RE: Fort Street Public School

Thank you for the opportunity to provide feedback on the School Transport Plan for Fort St Public School.

Figure 1: Traffic calming strategy at Upper Fort Street, Dec 2021. (Source: Arup)

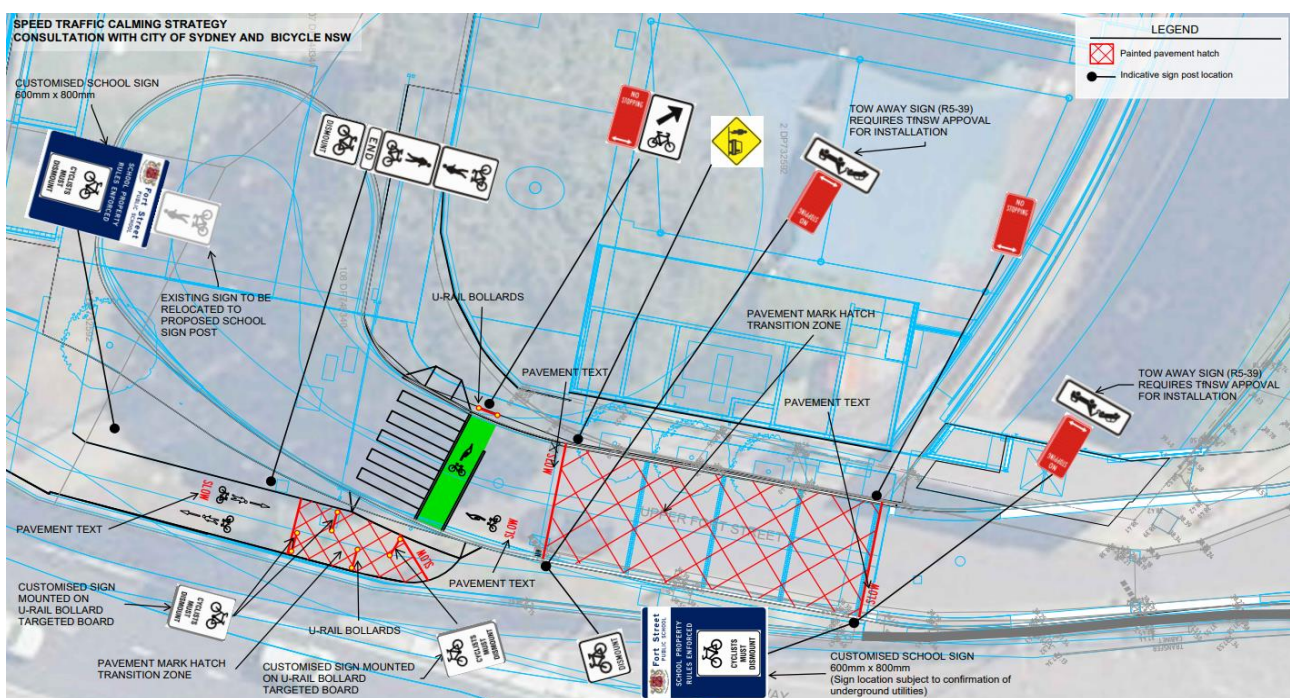
The traffic calming strategy plan for Fort Street Public School (Figure 1) does not deliver on the objectives set out in the School Transport Plan to encourage sustainable transport, prioritise walking and cycling, reduce reliance on cars and tackle childhood obesity (Section 1.5, p. 2). Instead, a series of traffic calming interventions have been suggested that will exacerbate risk for people riding or walking, and, as a result, encourage vehicular traffic.

The proposal for a series of 4 u-rail bollards blocking the cycleway and signs requiring cyclists to dismount are completely unacceptable and unworkable in the location shown.

- Chicanes and bollards are unsafe. There are high risks to cyclists in relation to the use of chicanes or bollards which are generally prescribed for the protection of sensitive infrastructure from traffic intrusion. Austroads Part (6A section 10.1) considers their use in the context of railway crossings. The unnecessary use of traffic terminals on cycleways risks serious injury to bicycle riders, and the strong possibility of litigation.

- Chicanes increase congestion. Forcing riders to come to a dead stop and dismount is inconvenient and raises the risk of collision and conflict. This is a critical consideration given southbound cyclist traffic at peak hour will increase substantially once the northern ramp to the Harbour Bridge Cycleway is delivered as promised.

- Maneuvering around chicanes is often impossible for personal mobility devices, cargo bikes and large prams. Wheelchairs and mobility scooters will be particularly challenged. We doubt the design is DDA compliant.

- The Harbour Bridge Cycleway is an important **regional route** and one of the busiest in Sydney. On a recent weekday peak hour 8-9am (on 3rd May), there were 360 bikes going south (6 per minute) and 185 bikes going north. There were 3152 trips throughout the day (Source: City of Sydney). Austroads Part 6A sets out the design speeds and acceptable treatments for regional cycle routes. Barriers forcing bike riders to stop dismount are not compliant. And if commuters have to wait while a parent with a cargo bike tries to navigate the chicanes, queues will spill into Upper Fort Street and chaos will ensue.

The 40km/h speed limit for Upper Fort Street school zone is unsafe and must be lowered.

- The Austroads Guide to Traffic Management Part 8 considers high pedestrian activity zones where the speed limits are reduced to 30kmph. These are prescribed for areas of high activity such as schools. Reducing the limit from 40km/h to 30km/h is proven to reduce risk to vulnerable road users. Pedestrians are safer and traffic still flows.

- The pedestrian and cycle crossing must be raised to further reduce vehicle speeds in the area.
- This section of Upper Fort Street could be treated as a shared zone with even lower speed limits.

- Whilst there is a 'kiss and ride' zone on Upper Fort St, how is Fort Street School catering for parents dropping off and picking up children by bike? The access point for bikes and pedestrians from the cycleway appears narrow and will get congested, with safety horribly compromised by the passing commuters.

- Cyclist and pedestrians accessing the school will be routed around the back of the loop of Upper Fort Street, effectively making it more convenient to arrive by car. How does this square with the stated aims of encouraging physical activity?
